PROJECT: Centennial Hills Memory Care Facility

SUBMITTAL: 1st Submittal

CITY OF LAS VEGAS		DATE:
INTER-OFFICE MEMORANDUM		October 24, 2016
TO: Land Development Services Department of Building & Safety		FROM: Albert Sung, P.E. Flood Control Project Engineer Department of Public Works
SUBJECT:	Drainage Study for:	
	Centennial Hills Memory Care Facility	
Cross Streets:	SWQ of Doe Brook Tr. & Deer Springs Way	COPIES TO:
File Number:	F:\Depot\DSMemos\DS4833A.doc	McCay Engineering
Parcel Number:	125-20-711-007	6630 Grand Montecito, LLC
Zoning Action:	SDR-67159	Bart Anderson, P.E., DevCo
FEMA Flood Zone	YES	NO X
Proposed Storm Drain	YES	NO X

**TECHNICAL DRAINAGE STUDY
FOR
CENTENNIAL HILLS MEMORY CARE FACILITY
(UPDATE #4 TO THE TECHNICAL DRAINAGE STUDY FOR CENTENNIAL BUSINESS PARK)**

GRADING PLAN

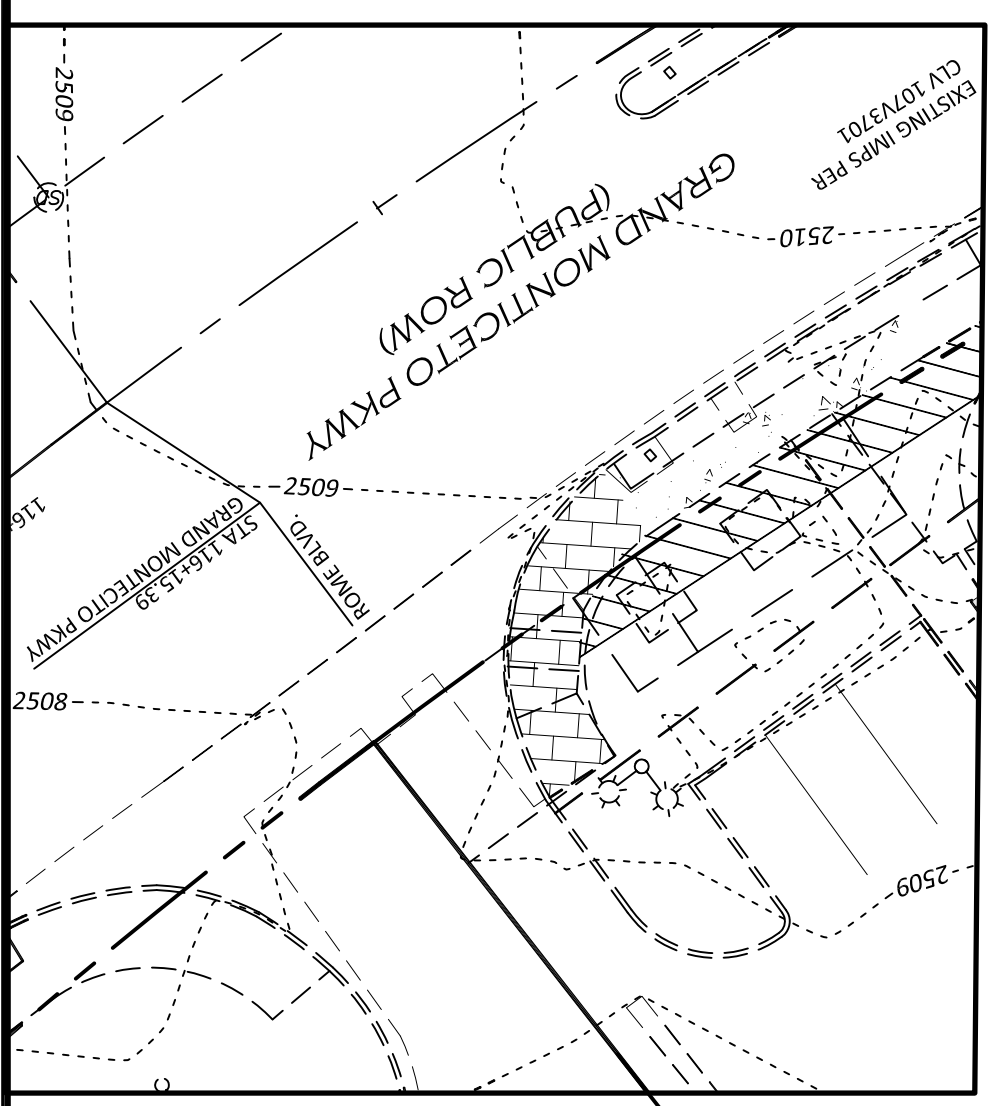
1. Provide a copy of the zoning/planning conditions associated with this site (**SDR-67159**) with the next submittal to verify compliance with conditions. *Flood Control* will not issue conditional approval of the drainage study without the associated zoning/planning conditions (issued by the *City Council*). Any associated conditions of approval that revise the site drainage parameters will require that the drainage study be revised and resubmitted.
2. The engineer proposed to connect a new onsite storm drain to an existing storm drain system which is already overburdened performing as a bubbler system. The engineer may consider to have the onsite drainage as surface flow and discharges at the southeast corner of the site. Review and revise accordingly.
